Service Bulletin SB-0039

Subject: Stick Shaker Harness Routing Improvement

Effectivity: K003 – K031

Affected Model(s): E1000, E1000GX

Figure 1: Stick Shaker Harness Routing Improvement (Sheet 1 of 2)

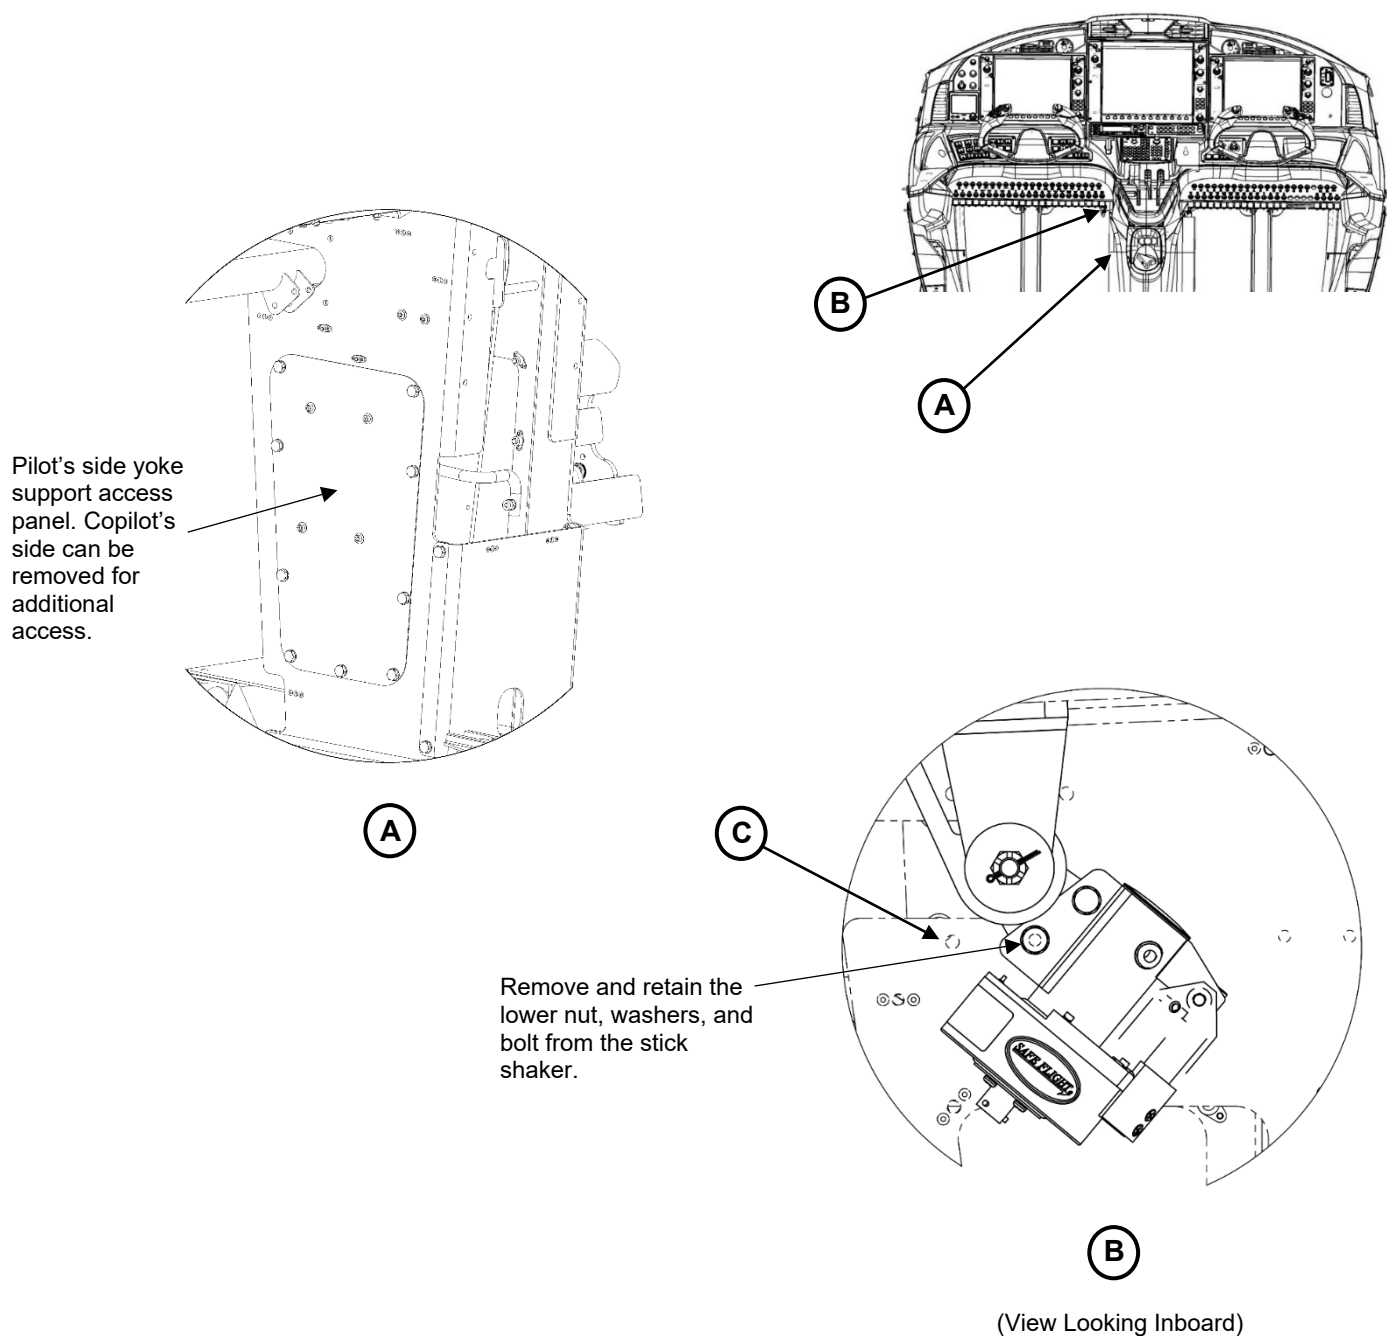
1. Set the BATT 1 and BATT 2 switches to OFF.
2. Disconnect external electrical power from the airplane (refer to Epic E1000 Aircraft Maintenance Manual, PN SK05000000, chapter 24-40).
3. Remove the pilot seat (refer to Epic E1000 Aircraft Maintenance Manual, PN SK05000000, chapter 25-10).
4. Remove the pedestal finish panel (refer to Epic E1000 Aircraft Maintenance Manual, PN SK05000000, chapter 25-10).
5. Remove the pilot's side yoke support access panel (refer to Figure 1, Sheet 1).

- d. Solder the wires in the new 90° connector:
 - i. K3150329C-22 to pin A
 - ii. K3150310A-22N to pin B.
8. Remove the lower nut, washers, and bolt that attach the stick shaker to the elevator torque tube. Retain the hardware (refer to Figure 1, Sheet 1).

9. Install the clamp on the stick shaker with the retained bolt, washers, and nut. Torque the nut to 20-25 in-lbs.
10. Put the second clamp in position on the harness.

Figure 1: Stick Shaker Harness Routing Improvement (Sheet 2 of 2)

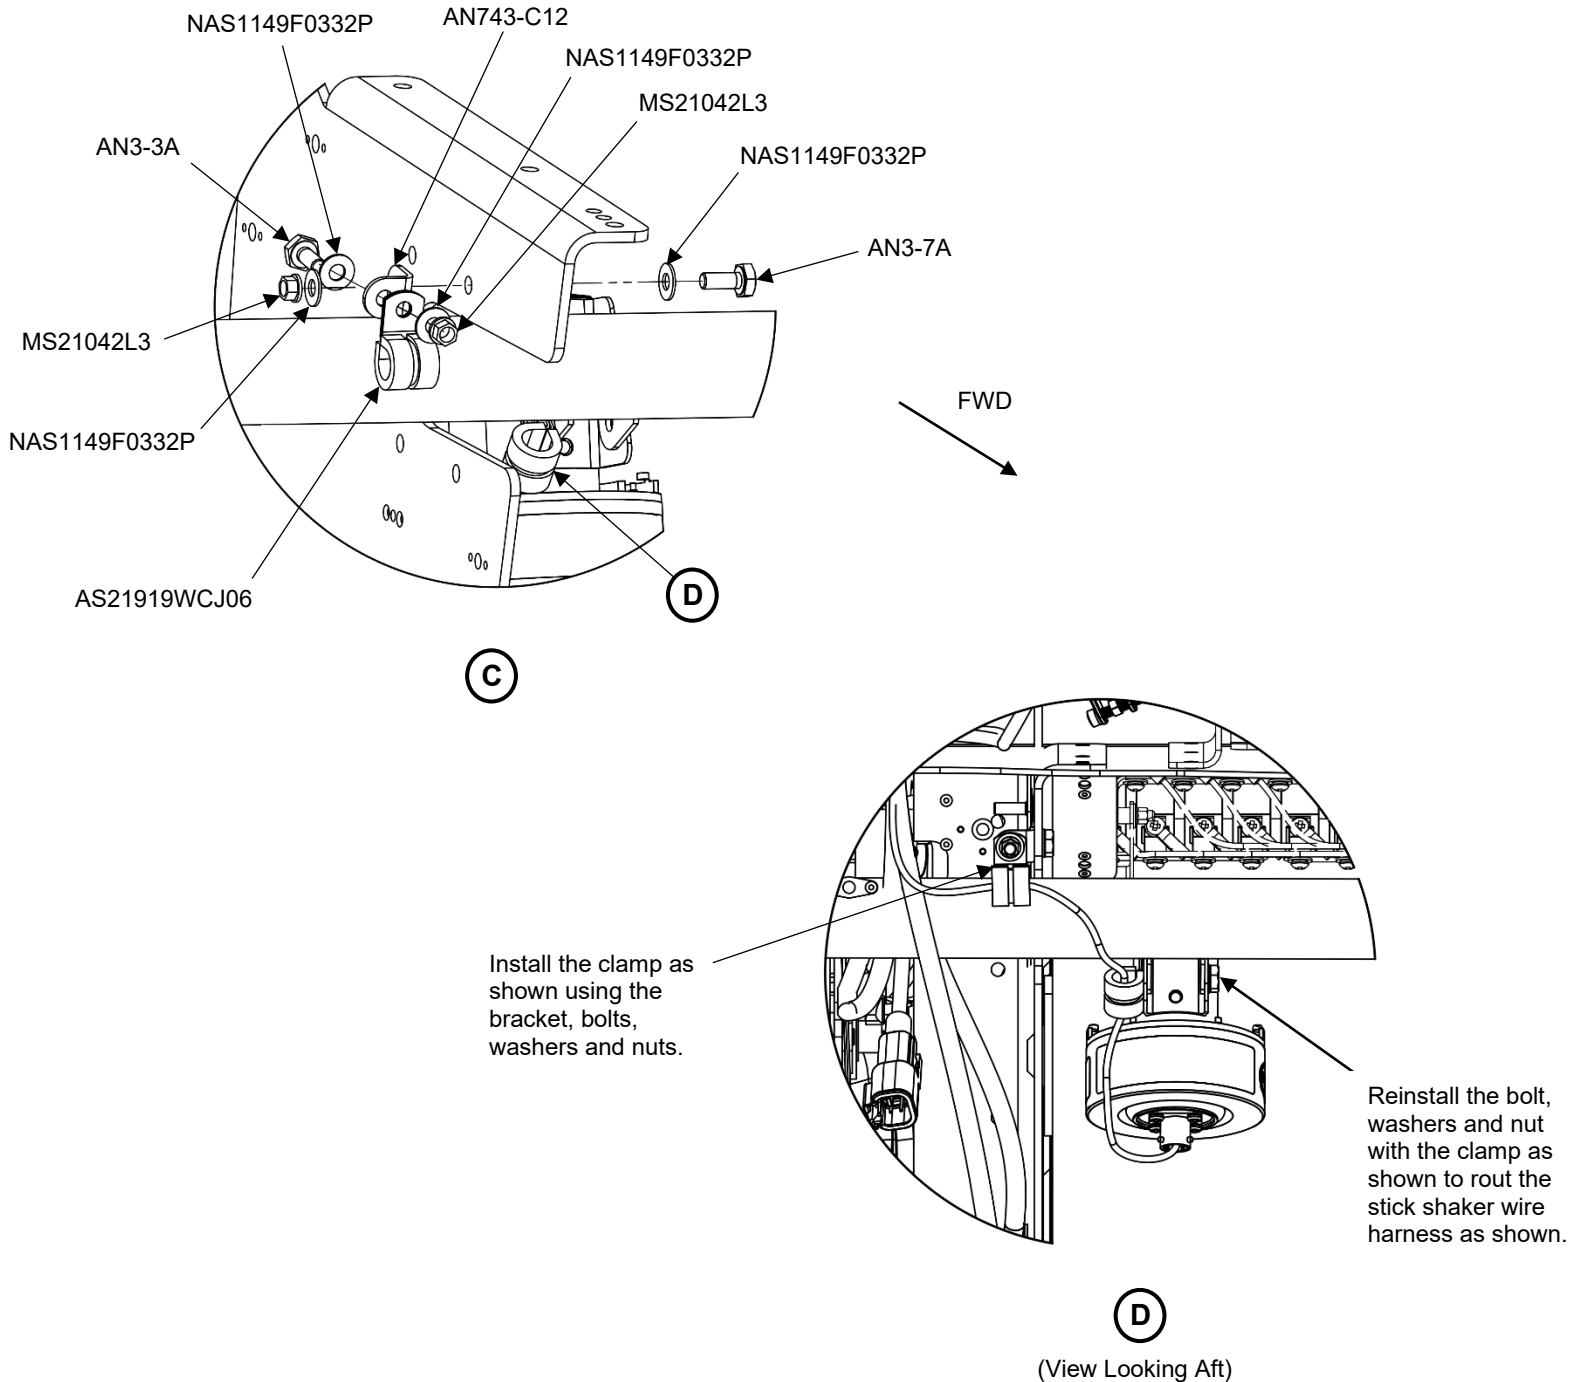
11. Attach the bracket to the clamp with the bolt, washers, and nut, (refer to Figure 1, Sheet 2 for the correct orientation of the bracket and clamp).

12. Attach the clamp/bracket assembly to the instrument panel support with the bolt, washers, and nut. Torque the bolt to 20-25 in-lbs.
13. Connect the P241 electrical connector to the stick shaker.

Figure 2: Stick Shaker Harness Routing Improvement – Final Installation

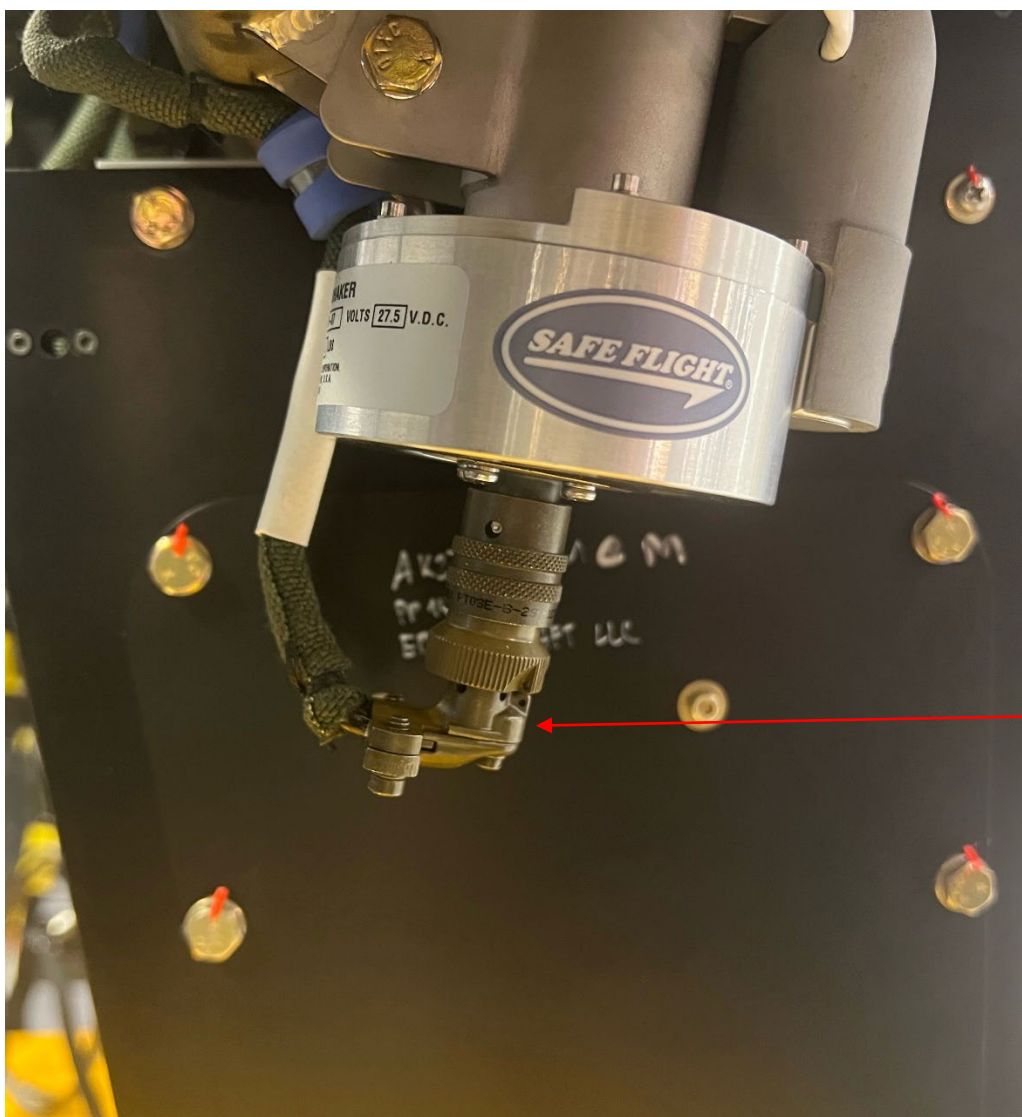
- b. Cut the two wires from the P241 connector.
 - c. Install the electrical connector backshell so the strain relief is oriented forward and slightly inboard. (Refer to Figure 2)
